Product Change Notice (PCN)

PCN Number: PCN-0450049R-01

Product(s) Affected: PJ-082BH

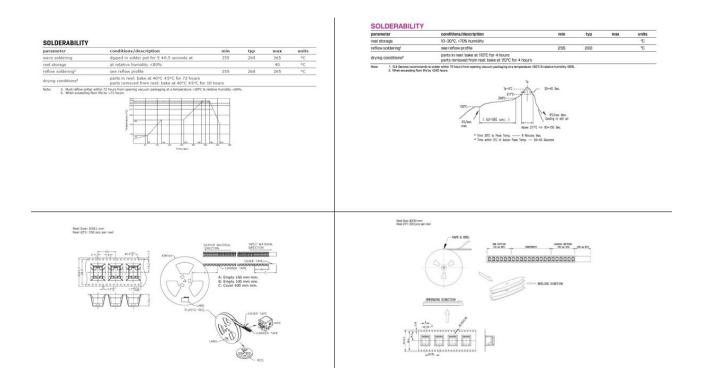
Description of Change: Mechanical, electrical, and material changes as shown below:

MATERIAL	PLATING
brass	silver
copper alloy	silver
cold rolled steel	nickel
cold rolled steel	nickel
stainless steel	
PA6T or equivalent	
	brass copper alloy cold rolled steel cold rolled steel stainless steel PA6T or

DESCRIPTION	MATERIAL	PLATING/COLOR
terminal 1	brass	silver
terminal 2	copper t=0.30	silver
stopper	SUS 301 t=0.30	
shield A	SPCC t=0.40	nickel
shield B	SUS 301 t=0.15	
housing	PA9T (UL94V-0)	black
